Name of Dam: Lake Heritage Dam

Inventory Number: VA 03332

PHASE I INSPECTION REPORT NATIONAL DAM SAFETY PROGRAM.

Lake Heritage Dam (Inventory Number VA-03332),
York River Basin. Caroline County,
Commonwealth of Virginia. Phase I Inspection
Report.

PLATE 7

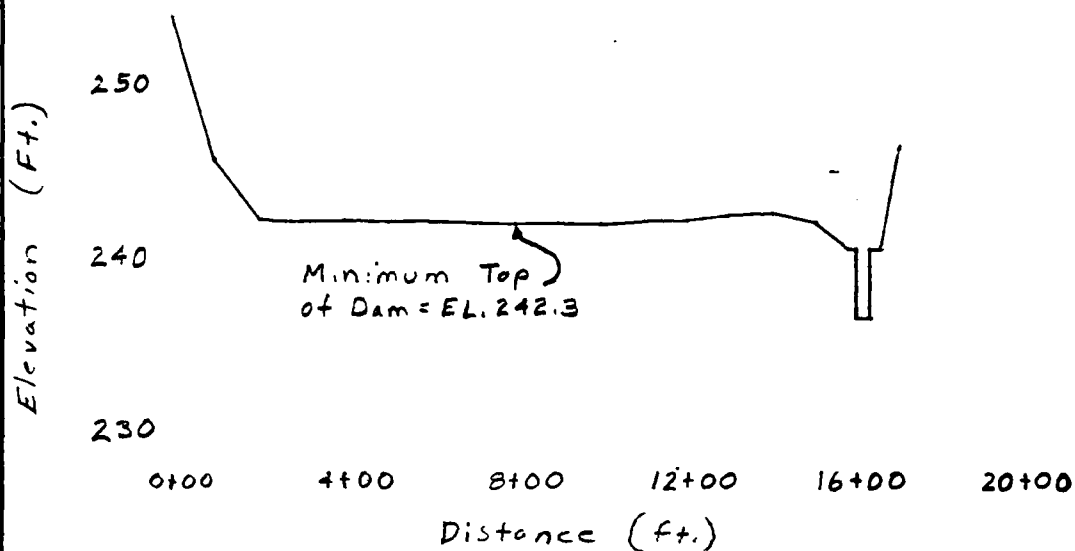
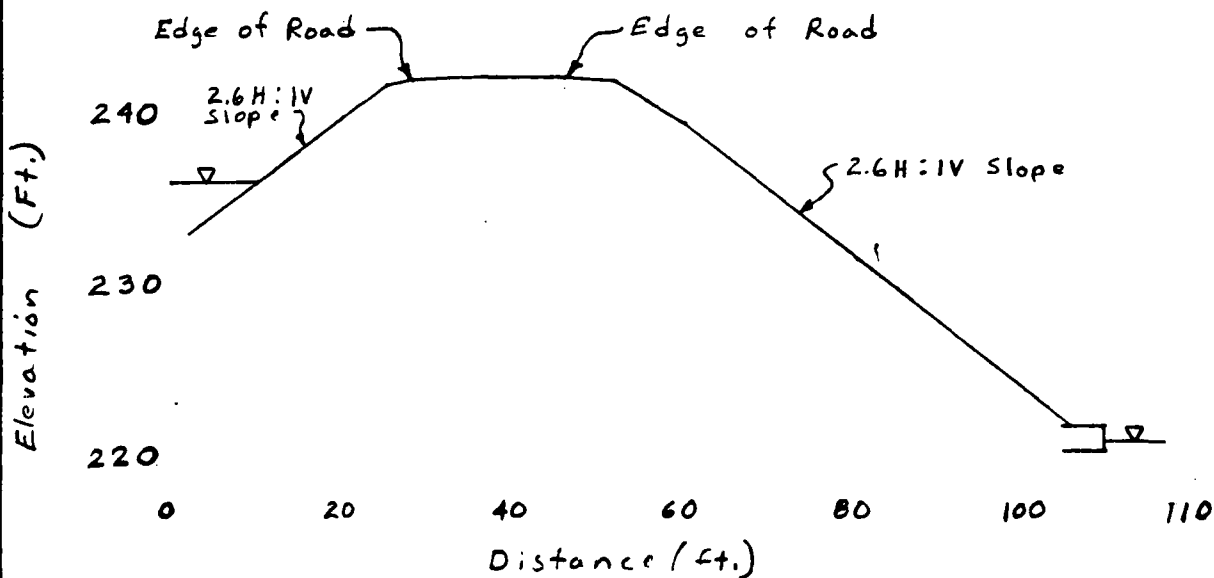
Signs of instability in the embankment such as slumping, tension cracks, or unusual alignment along the crest were not observed during the visual inspection. The lower section of the downstream embankment was generally dry even though an internal drainage system was not provided. No seepage through the embankment or along the toe of the dam was observed. The entire downstream embankment (particularly the right side) is sparsely vegetated and moderately eroded. The toe of the downstream embankment near the center of the dam has been eroded slightly by local runoff that is channeled between the dam and the sewage treatment plant that is situated immediately downstream of the dam (see Plate 1 and Photo 7). The channel is a few feet deep locally.

PHOTO 7. Eroded Toe of Dam (Sewage Treatment Plant on Right)

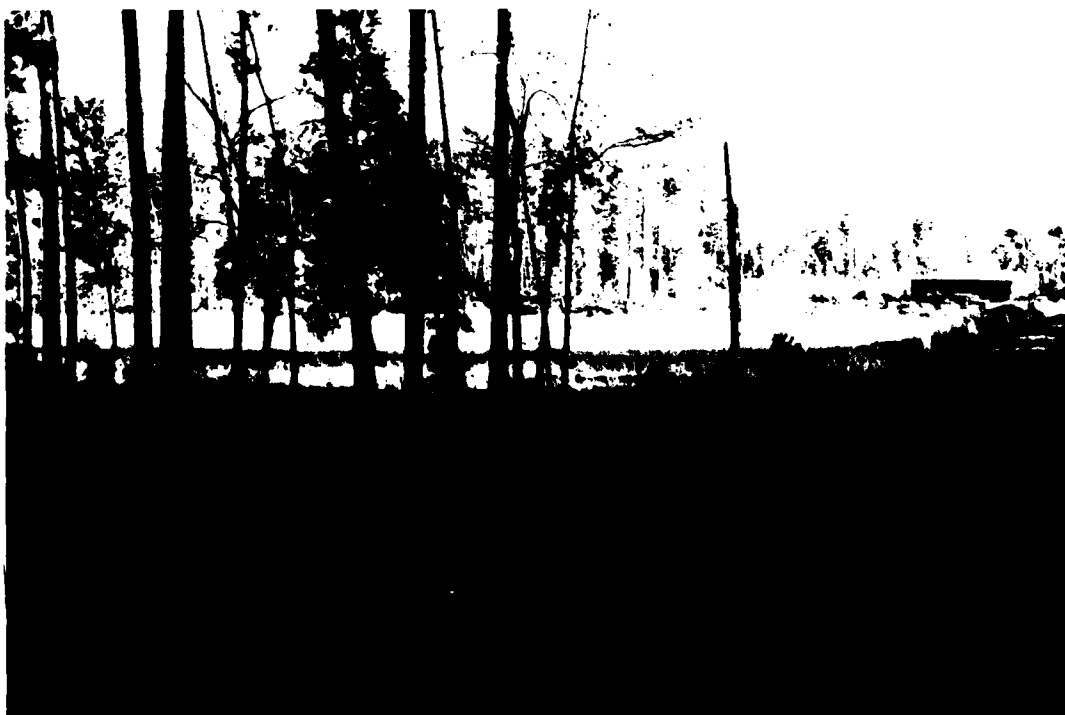
The toe of the downstream embankment has been slightly eroded by local runoff that is channeled left to right between the dam and sewage treatment plant, situated immediately downstream of the dam. A swampy area was noted along the toe of the dam. This is believed to be related to the runoff that drains left to right along the toe.

- 6) Place riprap in the drainage channel at the toe wherever the channel is in contact with or in close proximity to the toe of the embankment.
- 7) Monitor the roadway drainage channels on the right side of the embankment for erosion.
